**WEIRTON SANITARY BOARD  
BROOKE COUNTY, WEST VIRGINIA**

**CONTRACT #1 – WASTEWATER TREATMENT PLANT UPGRADE**

**ADDENDUM #2**

**THRASHER PROJECT #020-01649**

SHEET No.  
**10B**

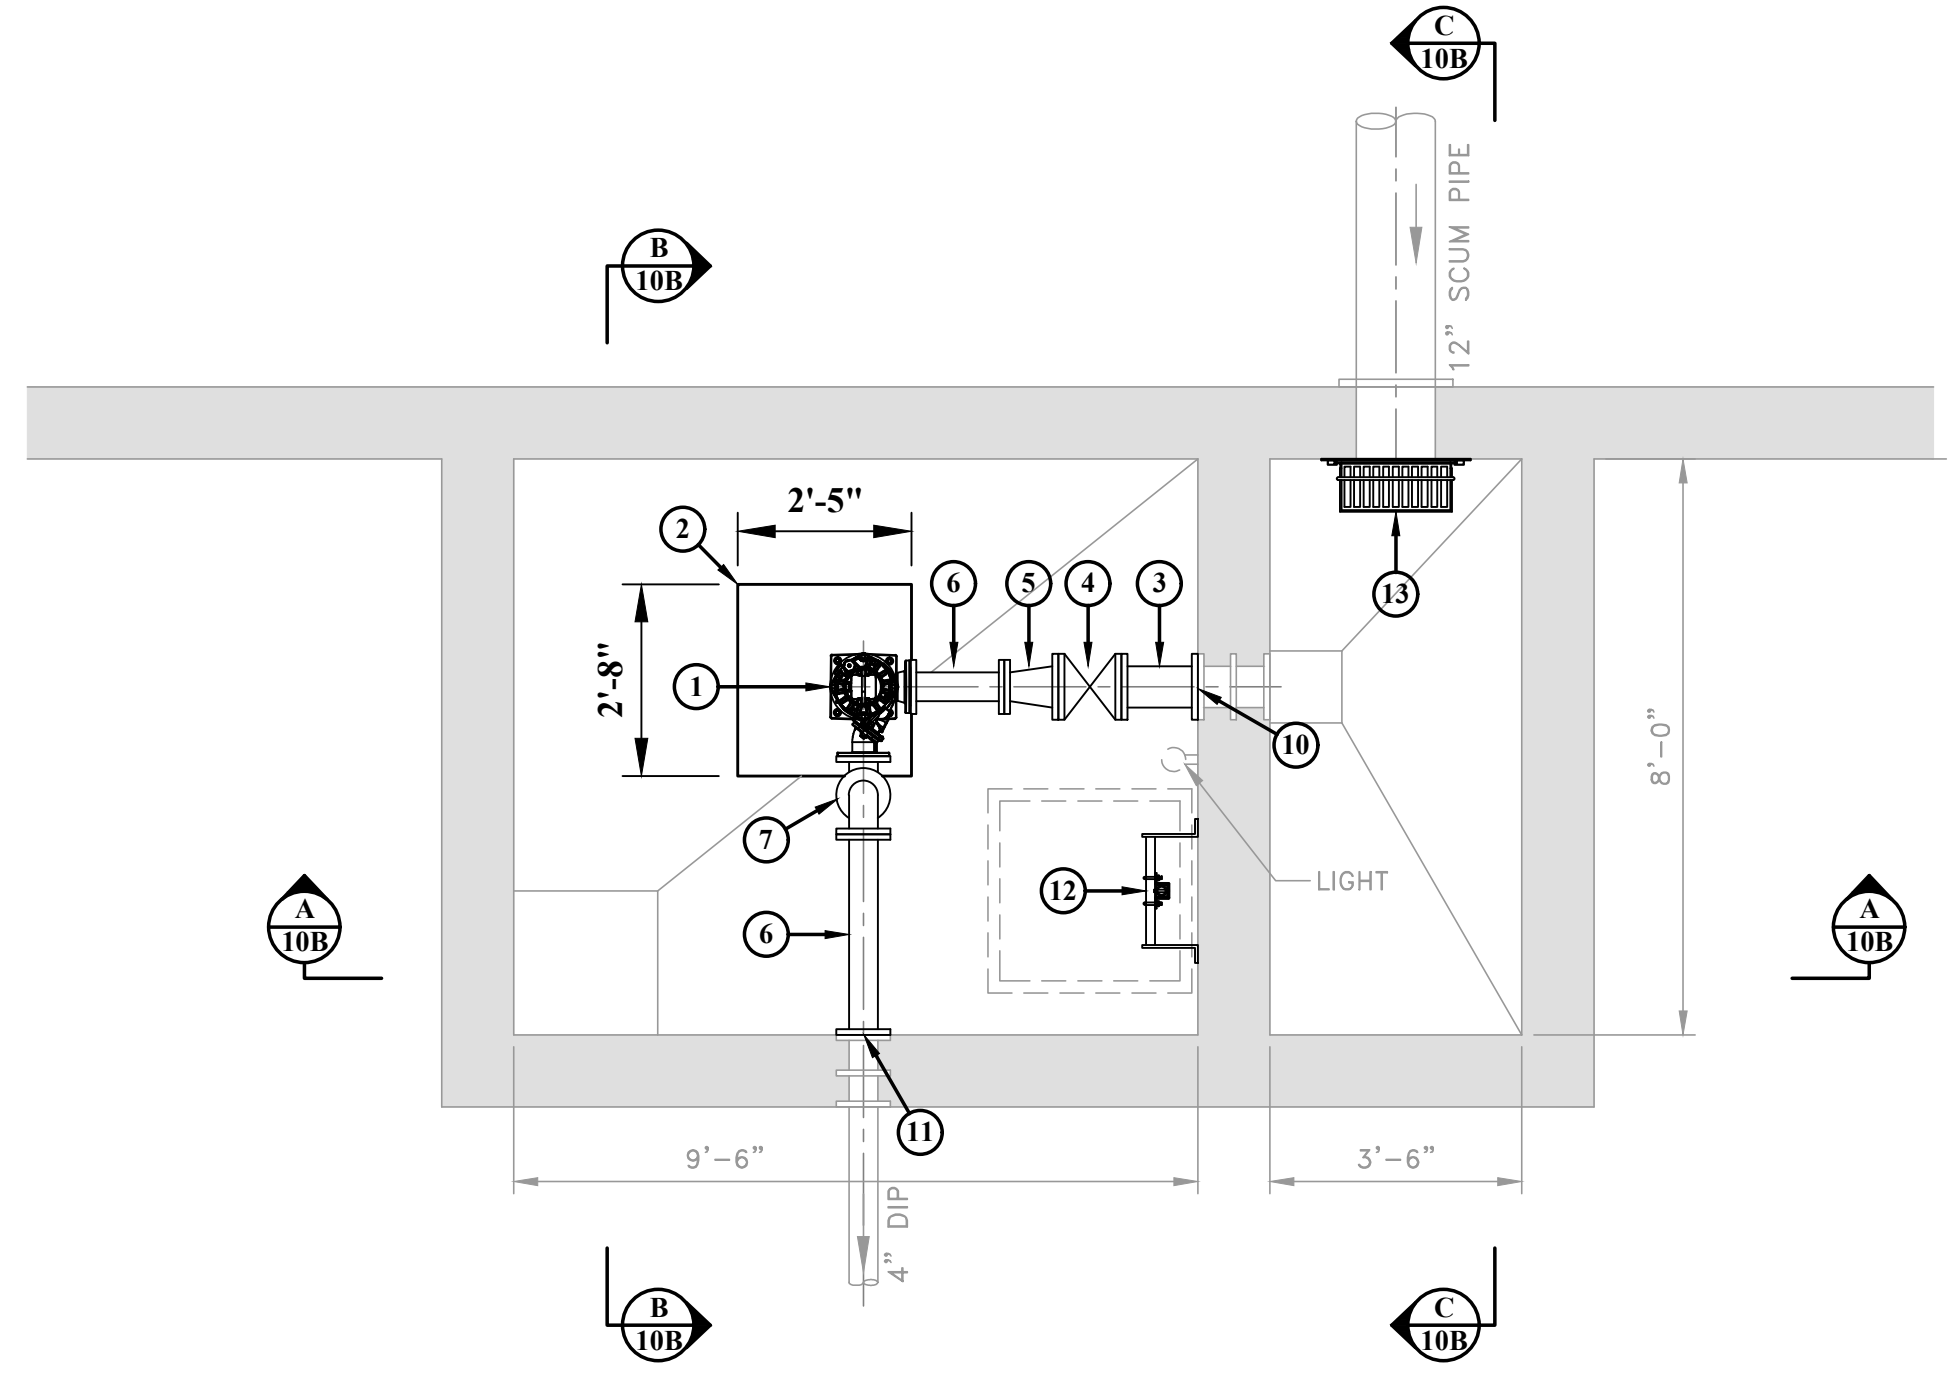
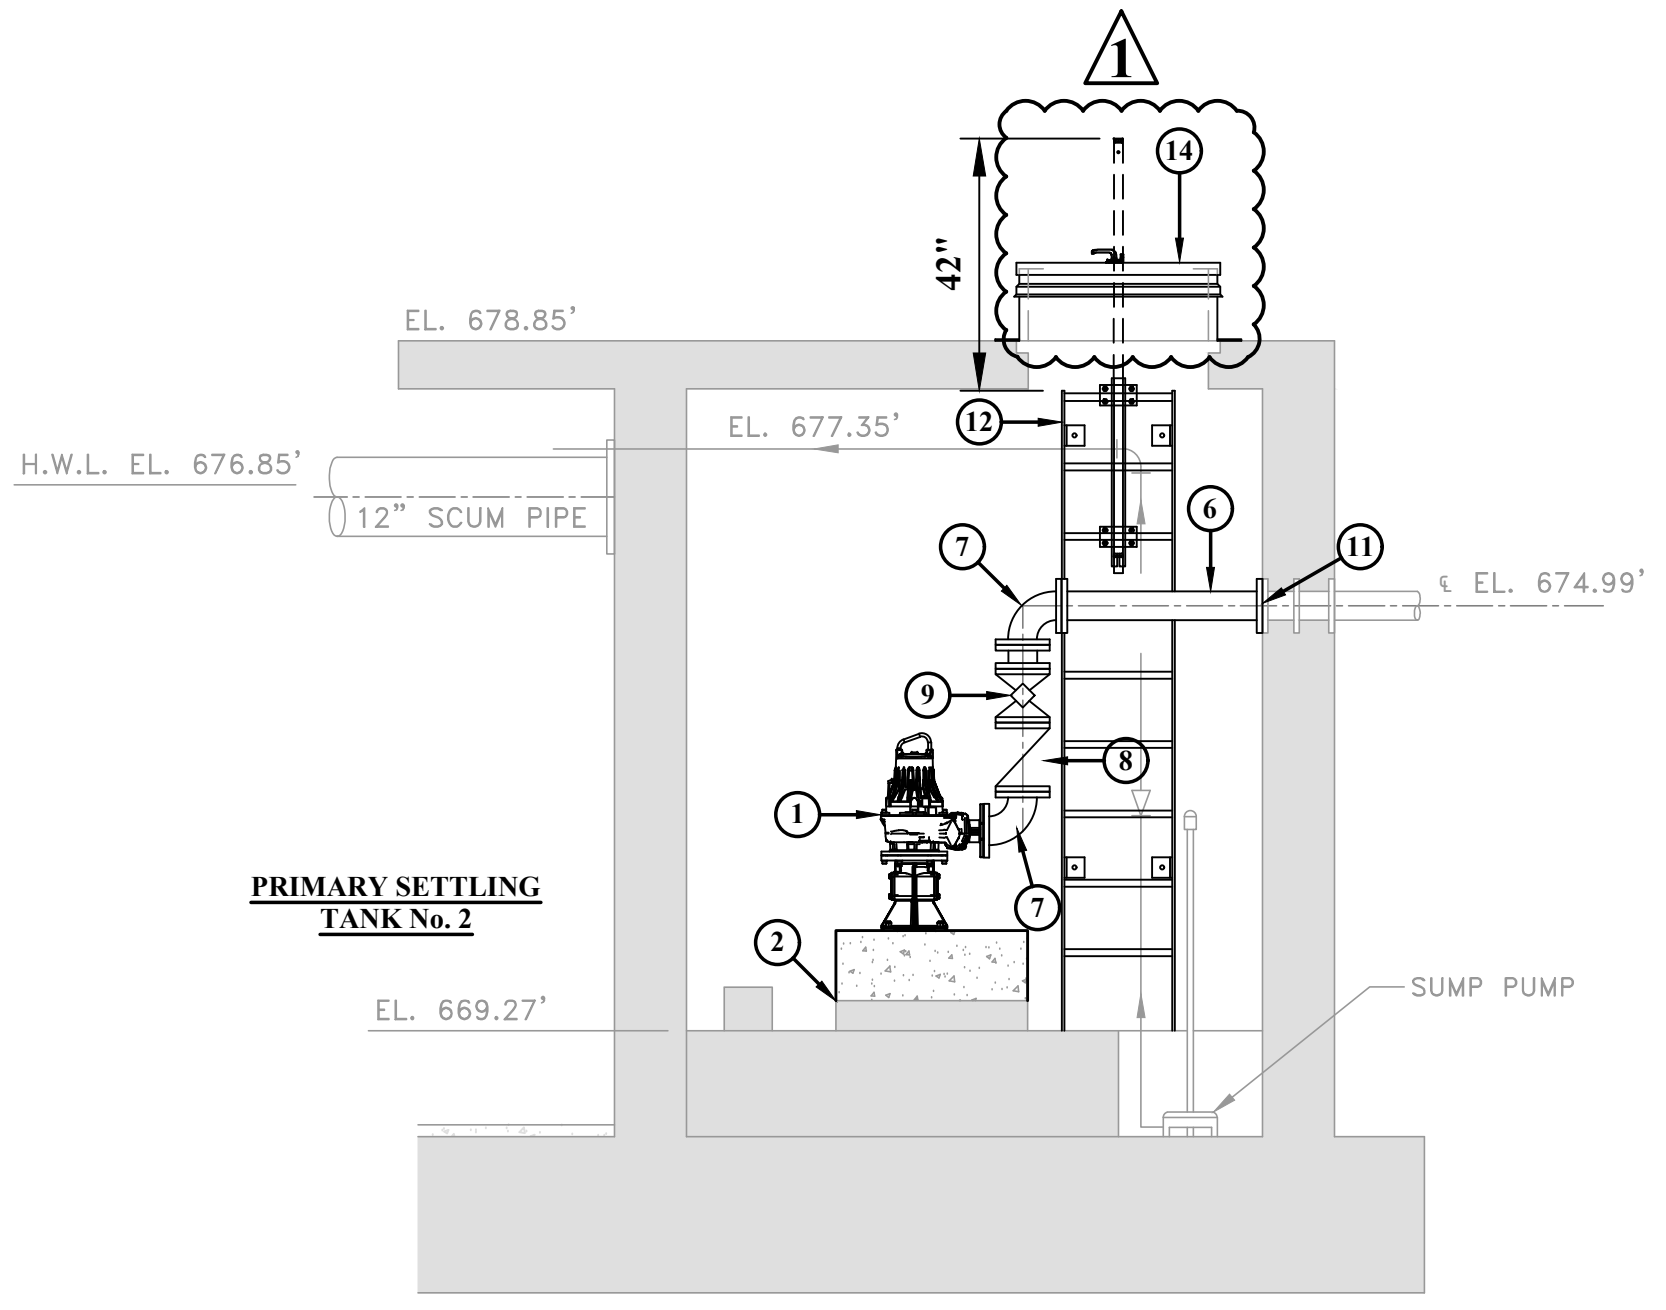
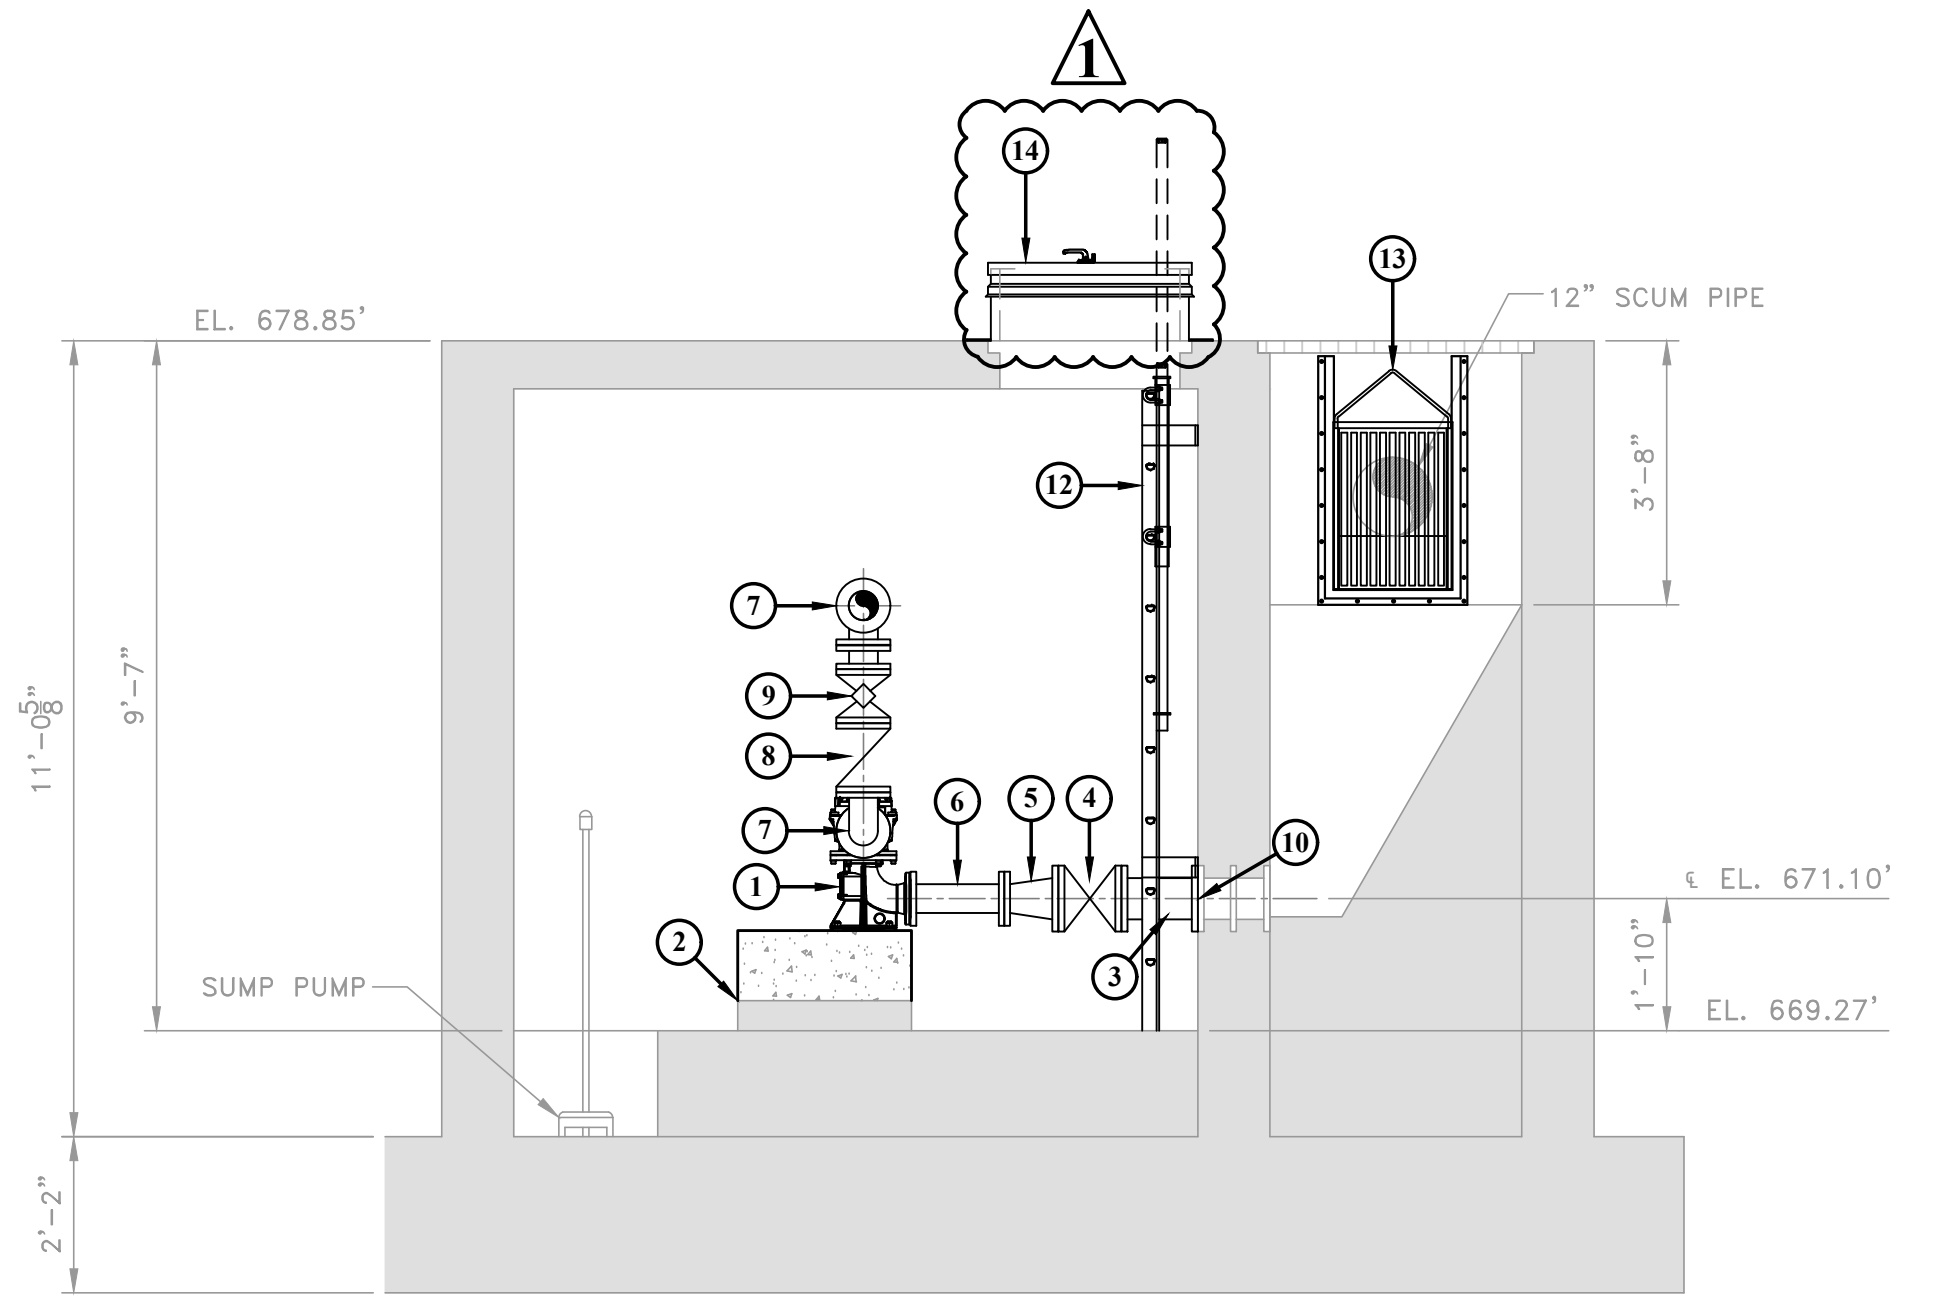
NO.	BY	DATE	DESCRIPTION
1	JLA	10/25/23	ADDENDUM No.2 - ADDED NEW ACCESS HATCH

SHEET No.  
**11K**

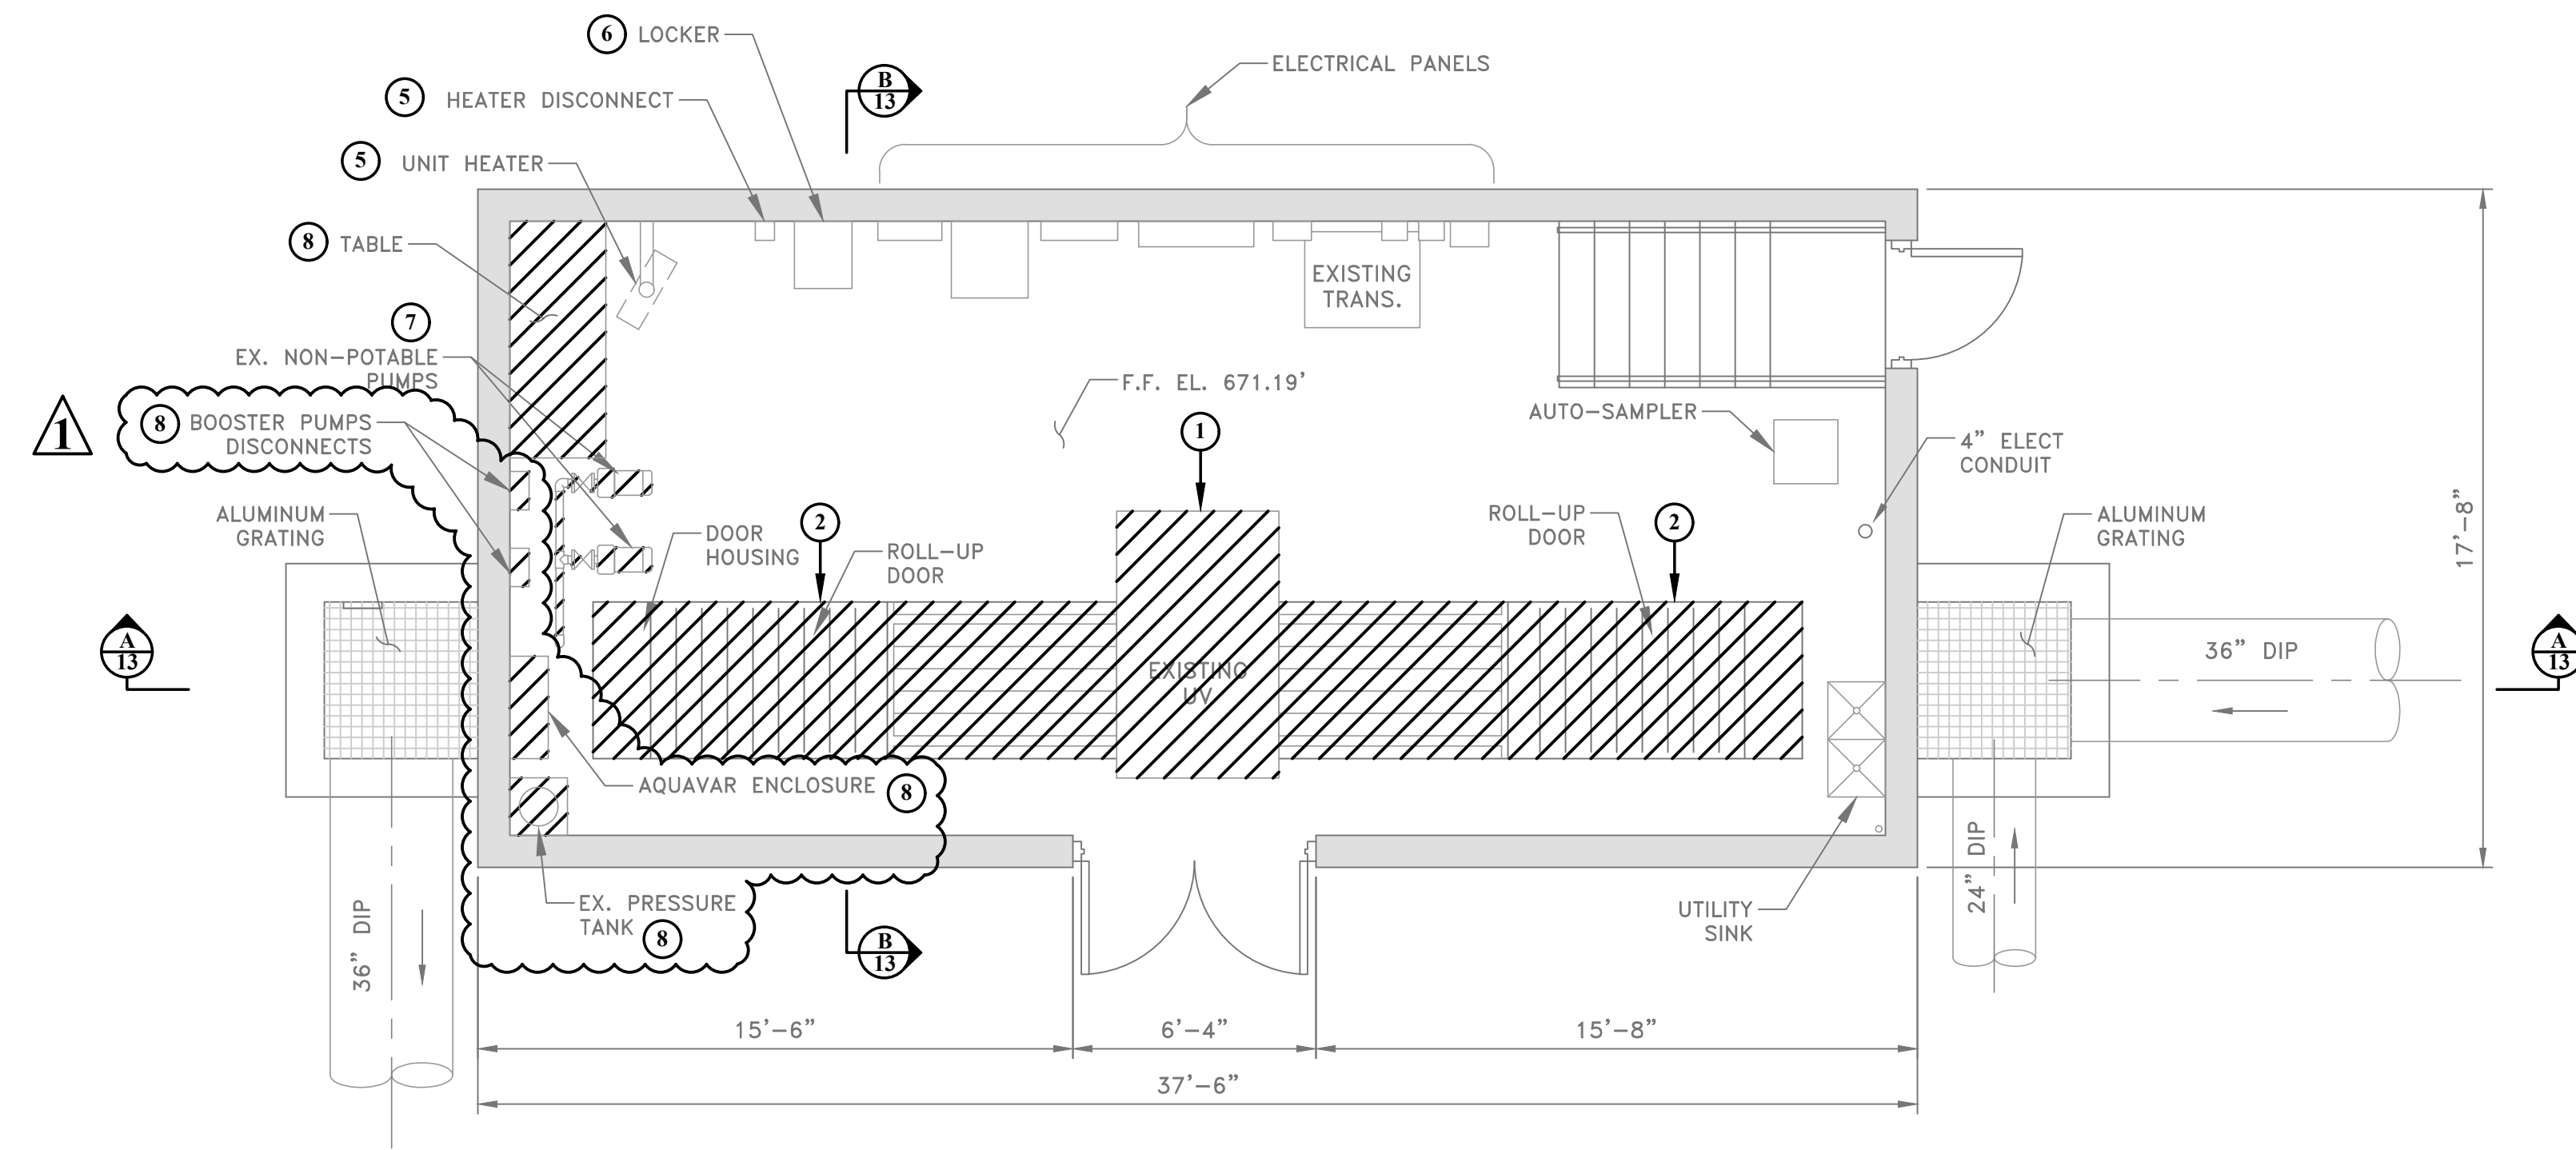
NO.	BY	DATE	DESCRIPTION
1	JLA	10/25/23	ADDENDUM No.2 -- ADDED 12" EXPANSION JOINT
